ITEM	10
MANAGER'S REPORT NO.	46
COUNCIL MEETING	90/07/09

TO: MUNICIPAL MANAGER  
 FROM: DIRECTOR PLANNING & BUILDING INSPECTION  
 SUBJECT: PROPOSED INSTALLATION OF A VAPOUR RECOVERY SYSTEM FOR SHELL'S TANK TRUCK LOADING RACK AT 2751 UNDERHILL AVENUE, BURNABY  
 PURPOSE: To provide Council with information on Preliminary Plan Approval application #9744

DATE: 1990 July 04

\* SKETCH SHOWING APPROXIMATE LOCATION OF PROPOSED NEW VAPOUR RECOVERY SYSTEM AT SHELL'S EXISTING TANK TRUCK LOADING RACK.  
 2751 UNDERHILL AVE.  
 PPA # 9744

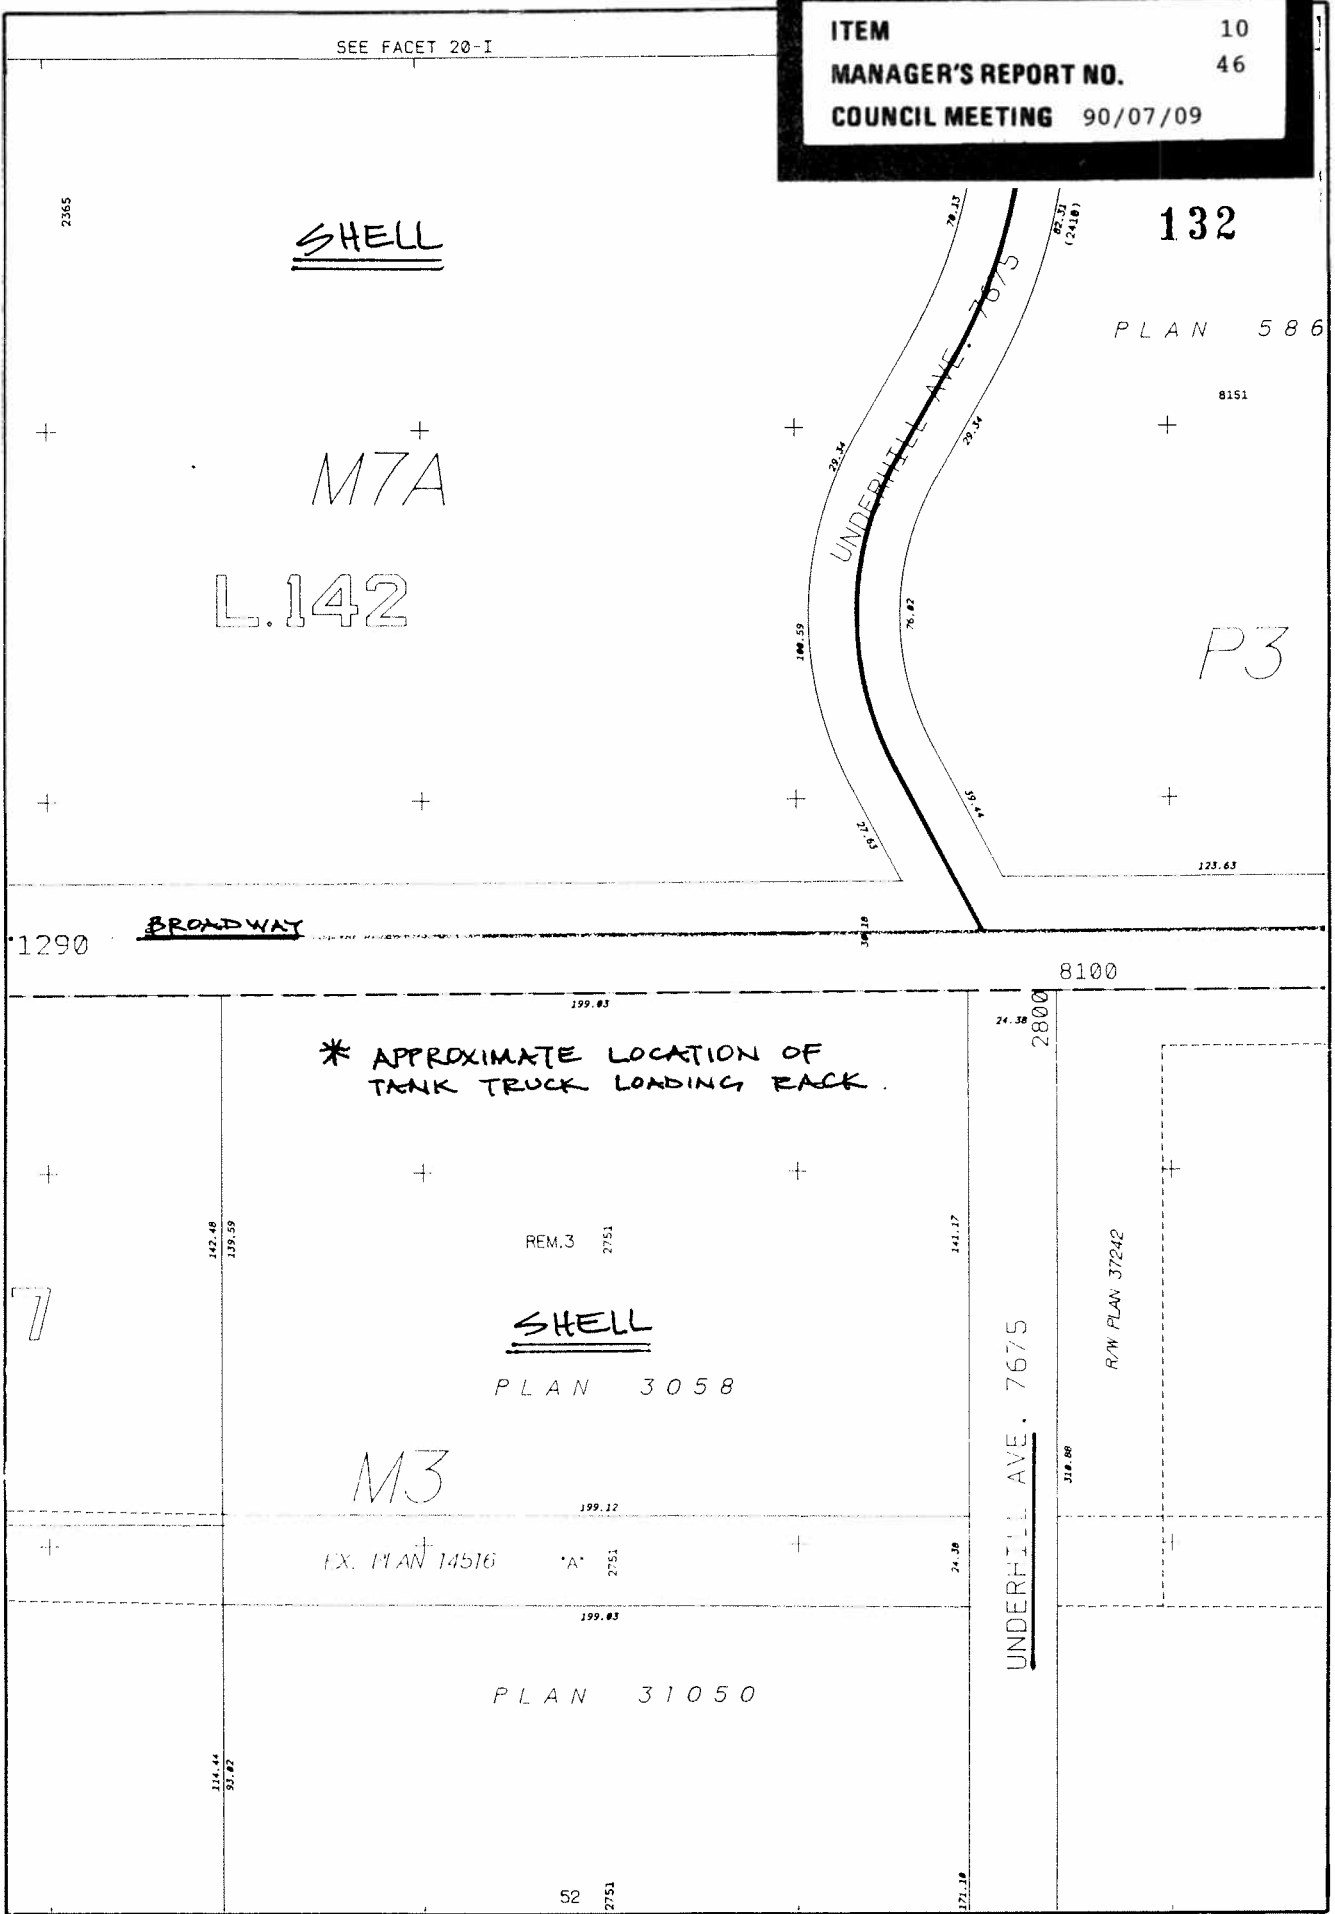
"This Department has reviewed the subject P.P.A. #9744 from Shellburn Refinery for installation of a vapour recovery system for tank truck loading rack at 2741 Underhill Avenue and have no objections to its approval in principle provided that the following noted requirements are met.

- 1. A detailed plan of the vapour recovery system along with a summary of its operation, generation of by-product and subsequent disposal (if any), and emergency procedures in an event of system failure must be provided to this Department.
- 2. The vapour recovery system shall be capable of collecting all organic vapours and gases, with a vapour return or disposal system capable of processing such vapours or gases so as to prevent their emissions to the atmosphere at an efficiency of at least 95 percent by weight.
- 3. All pipings, valves and fittings must be vapour tight."

3.3 The applicant has indicated that no more than 10 mg of hydrocarbon vapour per one litre of product loaded will escape to the atmosphere. They further indicate that the recovery rate of the subject system is 98% or better during normal operating capacity.
